Re: Indian Point Unit Nos. 2 & 3
Docket Nos. 50-247 & 50-286
NL-08-074

SUBJECT: Entergy Nuclear Operations, Inc.
Indian Point Nuclear Generating Unit Nos. 2 & 3
Docket Nos. 50-247 and 50-286
Amendment 4 to License Renewal Application (LRA)

Station Blackout / Appendix R Diesel Generator for IP2
LRA Amendment 4

**Station Blackout / Appendix R Diesel
License Renewal Application
Amendment 4**

Drawing LRA-400881-0

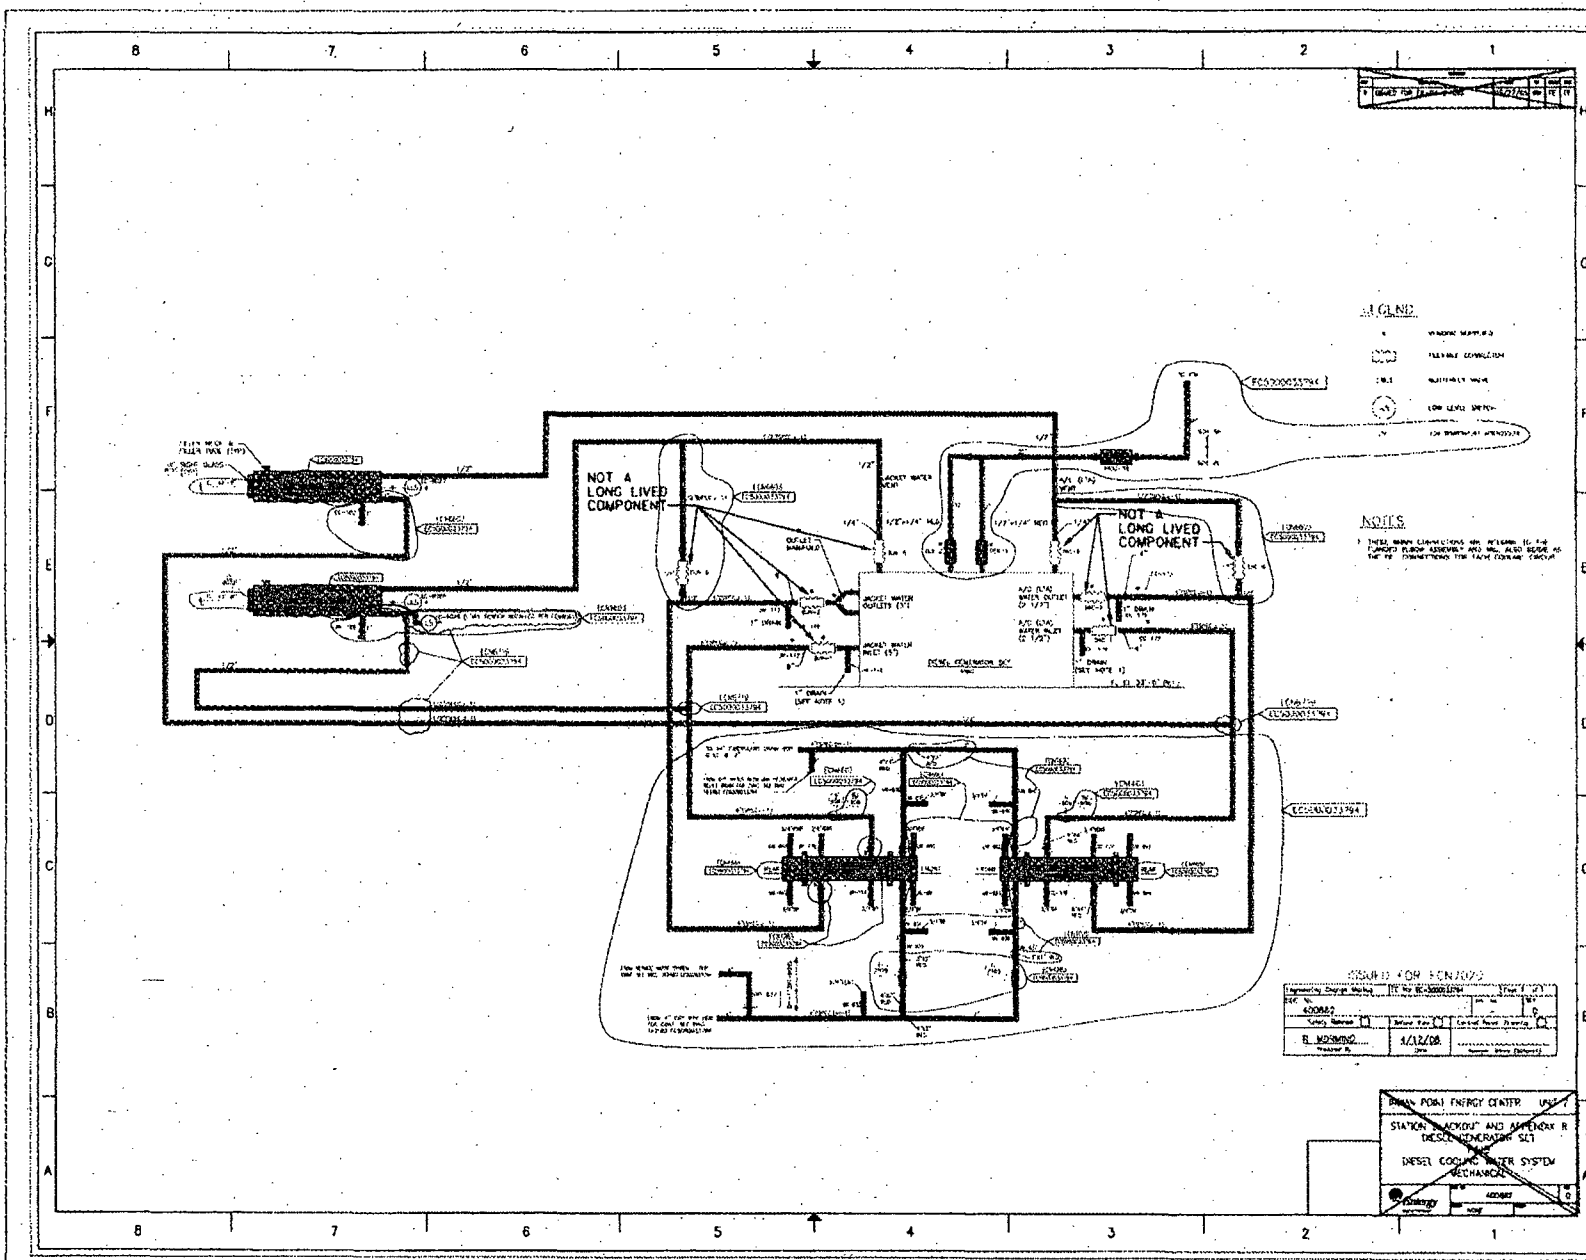
The SBO/ARDG ~~Appendix R diesel will be~~ is located inside the Unit 1 turbine building. The SBO/ARDG ~~Appendix R diesel generator installation will be a self-contained package that is~~ designed to operate upon a complete loss of power. ~~The package contains SBO/ARDG~~ includes batteries, a battery charger, jacket water heater and cooler, turbochargers, aftercoolers, aftercooler coolers, jacket water pump, lube oil heater and cooler, lube oil pump, and necessary filters and piping strainers. The SBO/ARDG ~~Appendix R diesel~~ generator can supply the safe shutdown loads through the 6.9 kV distribution and the emergency 480 V buses and motor control centers or the turbine building switchgear and motor control centers.

2.3.3.16, License Renewal Drawings, Unit 2, is changed to read as follows.
